The Township of East Garafraxa

Supplemental Consultant Planning Report to Committee of Adjustment

Subject: Minor Variance A2-25
Part Lot 10, Concession 14

APPENDIX A: Revised Site Plan

Site Plan (As provided by the Applicant)

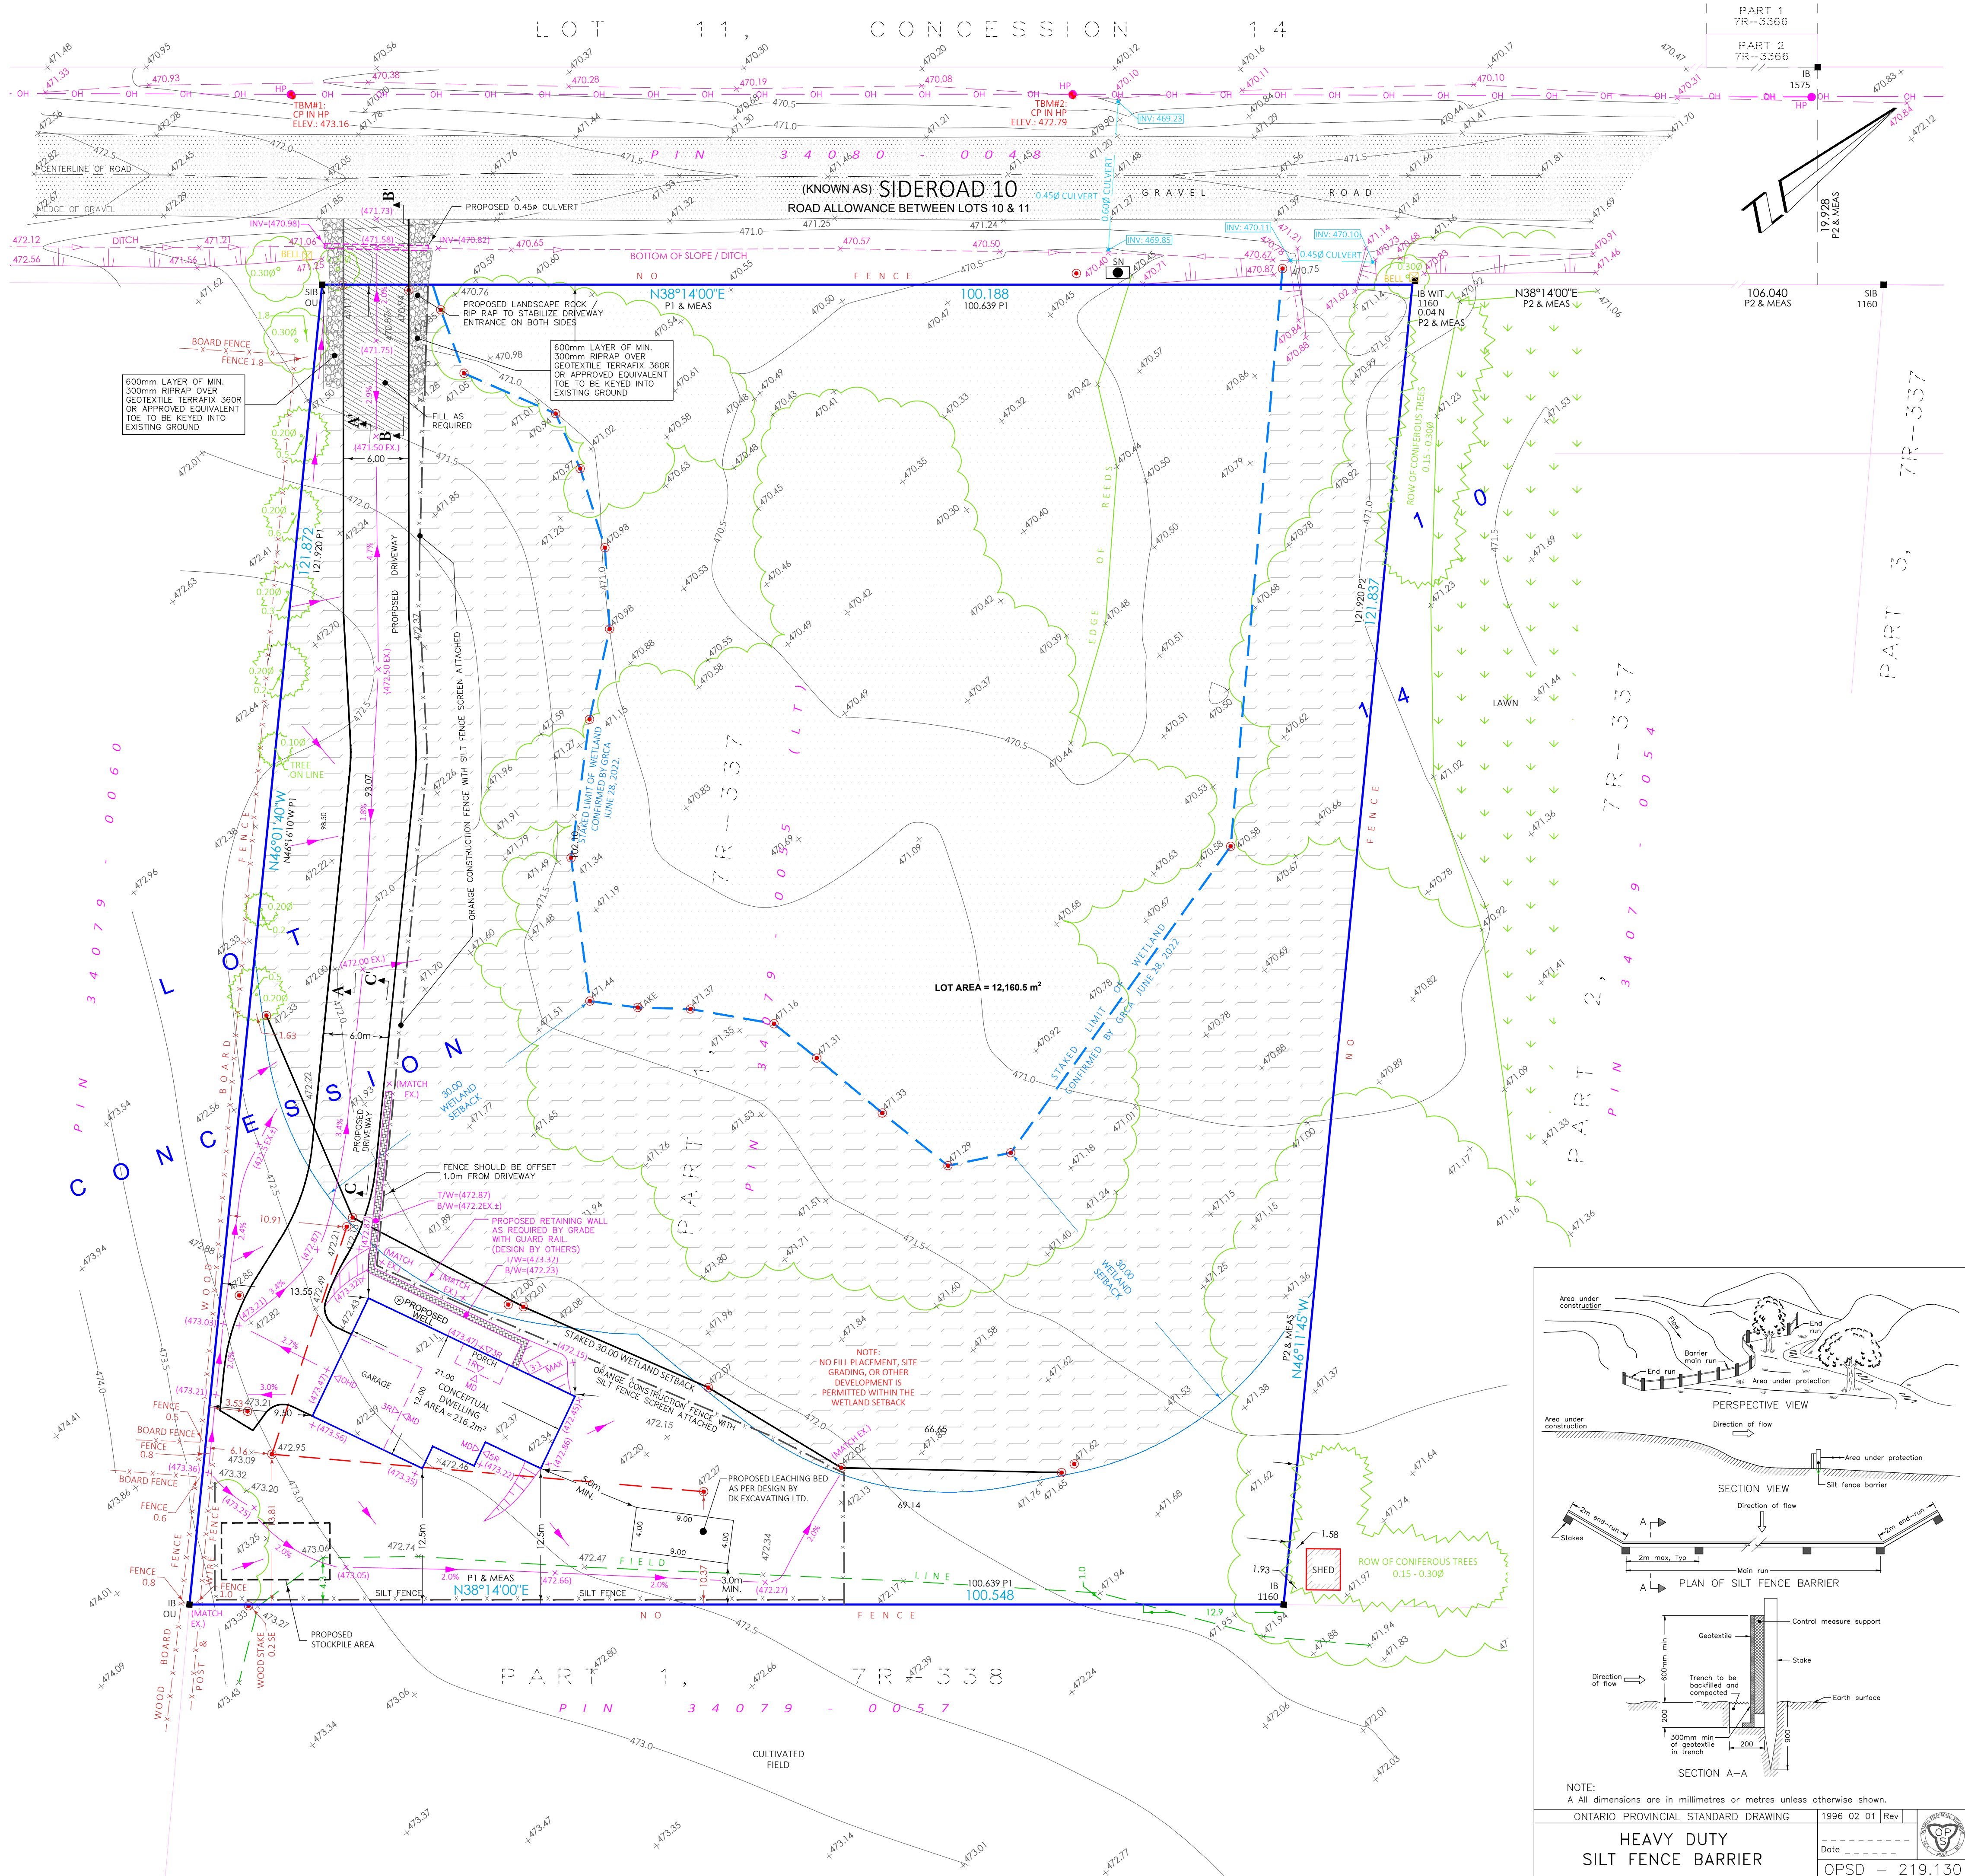
The applicant submitted a revised plan to the Township on April 30, 2025 (refer to Appendix A). The revised plan increases the requested rear yard setback from 7 metres to 12.5 metres. The increase rear yard setback was achieved by making a reduction to the building footprint (from 238.6 m² to 216.2 m²) and reorientating the proposed dwelling to align with the wetland setback boundary. The proposal maintains the wetland buffer established with GRCA. The septic system has been sized in accordance with the Ontario Building Code (OBC) and will be subject to a future building permit. The applicant has further indicated that there is no other suitable location on this lot for a building envelope given the constraints on the existing lot of record. The increase in the rear yard setback attempts to address concerns raise on the application and we are supportive of the increase to the setback. It is our opinion, that the revised rear yard setback of 12.5 metres is appropriate for the proposed development given the constraints on the property.

The applicant is still requesting the proposed variance for the MDS from the requirement of 110m to 70 metres. As indicated in our original report (dated March 19, 2025), there is an existing dwelling

located 45 metres from the existing livestock facility. The existing dwelling is located closer to the livestock facility than the proposed dwelling. As such, the livestock facility is already constrained by the existing dwelling adjacent to it. The proposed dwelling does not result in any constraints on the livestock facility which does not already exist. Therefore, it is our opinion that the reduction to the MDS is appropriate.

The applicant is seeking approval for relief from Zoning By-law 60-2004, as amended, with respect to the property located at Part Lot 10, Concession 14. Provision 4.3.2 iii) d) permits a minimum Rear Yard setback of 20 metres for Rural Residential zones. The revised site plan proposes to be located 12.5 metres from the Rear Lot Line. Therefore, relief of 7.5 metres is required. Provision 3.25.1 requires that all residential development adhere to relevant MDS setbacks, however, a required setback of 110 metres would preclude the Subject Property from development. As such, a variance of 40 metres is required to permit a 70 metre setback from the adjacent livestock facility. The requested variance is intended to facilitate the development of a single-detached residential dwelling located a sufficient distance from adjacent environmental and agricultural constraints, which otherwise complies with the provisions of the Rural Residential zone. There are no anticipated impacts on the subject property or the surrounding neighbourhood.
